## PLAN COMMISSION AGENDA

Tuesday, January 29, 2019  
6:00 PM

CSM – Mielke (Tax ID 43796)

CSM – Mielke (Tax ID 43768)

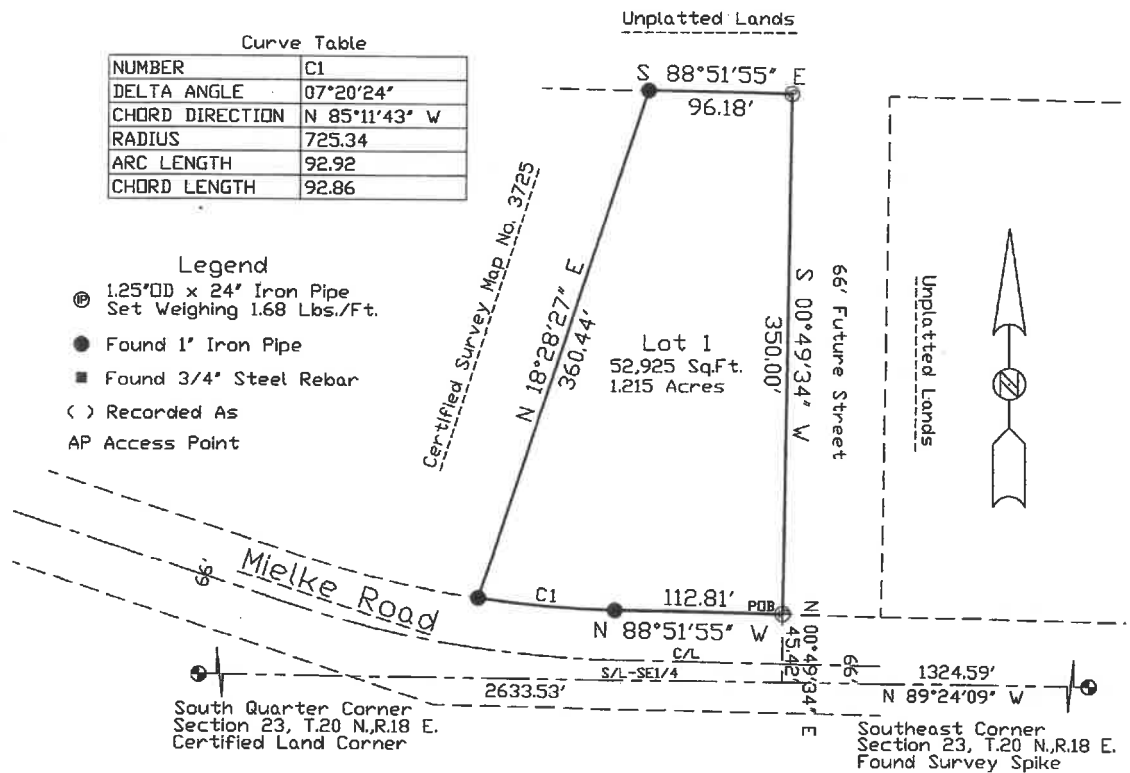
Staff has asked for a grading/drainage plan be developed for all the lots created and being proposed along Mielke Road. This will help ensure that the area develops in an orderly fashion and that future drainage issues are avoided.

Staff recommends approval of the CSM with the condition that a grading/drainage plan be reviewed and approved by the Village.

# PRELIMINARY PLAT "HIDDEN PINES SUBDIVISION"

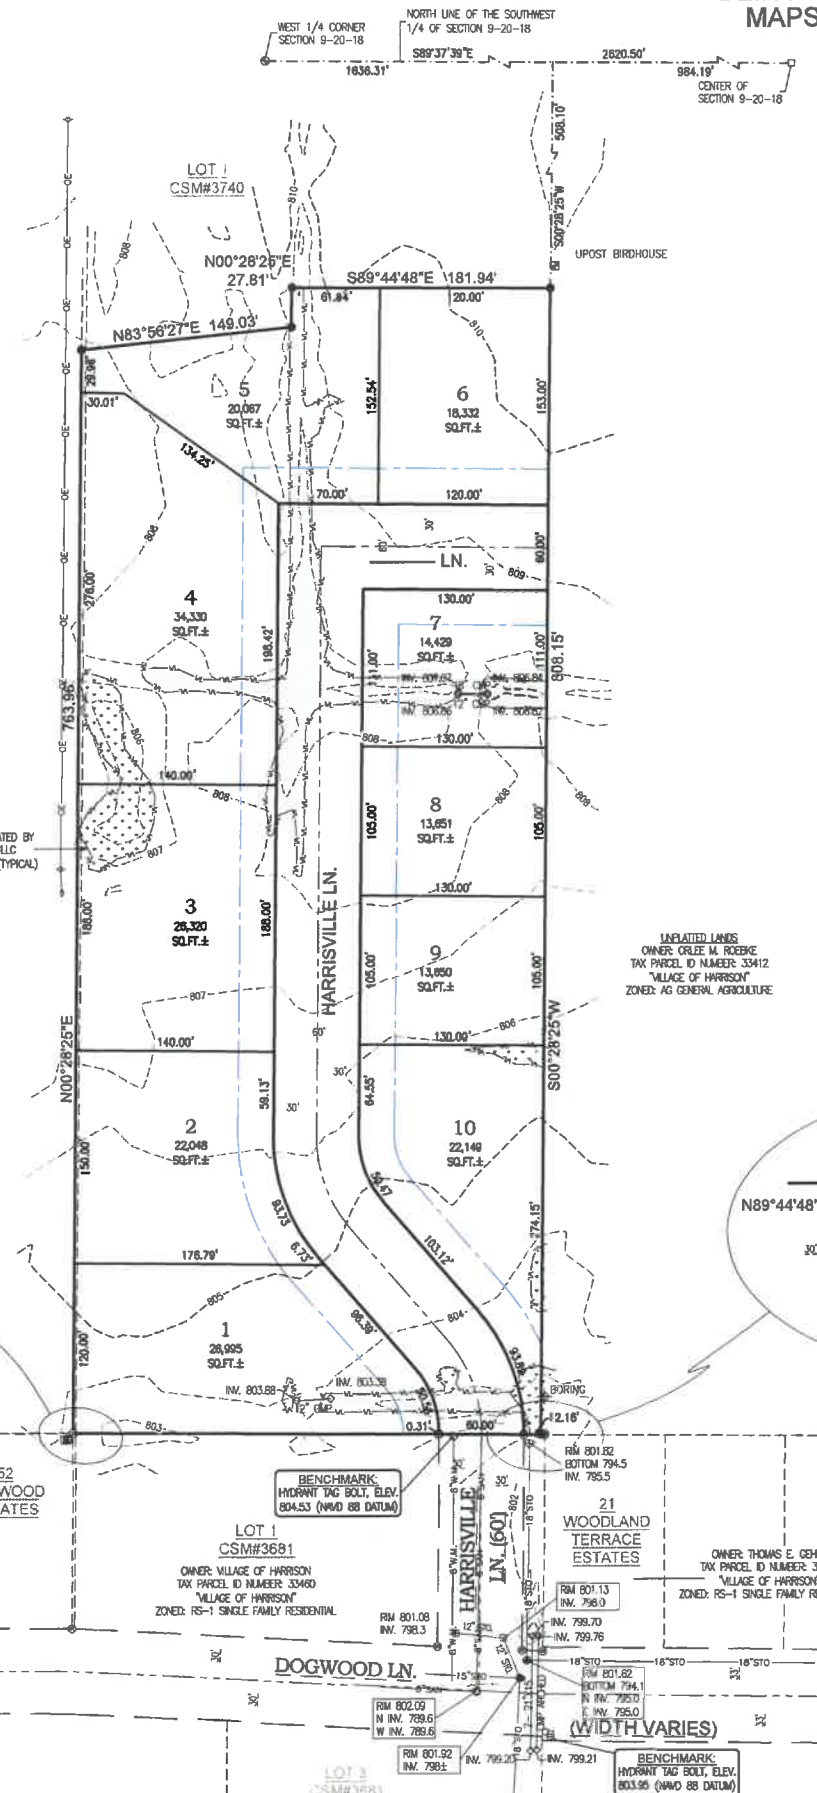
3. Final utility, street plans, and stormwater management/erosion control plans shall be reviewed and approved by the Village Engineer and Village staff in writing prior to approval of the Final Plat and prior to utility and street construction.

8. A note shall be added to the final plat indicating that the Village of Harrison will assess all lots for street improvements, including but not limited to, curb & gutter, concrete pavement, and sidewalks.

14. All comments from the Village engineer shall be included in the Plan Commission discussion and decision.
15. Location of all sidewalk curb ramps shall be approved by Harrison staff.

16. A grading/drainage stormwater management plan and erosion control plan shall be reviewed and approved by the Village engineer and Village staff.
17. Multiple benchmark locations shall be established for use during building construction.

18. All environmental corridors shall be clearly identified and setback lines to be indicated.
19. Grading/Drainage Plan shall identify elevations of ground at the foundation.

20. High-back, integral concrete curb shall be utilized rather than the mountable curb.
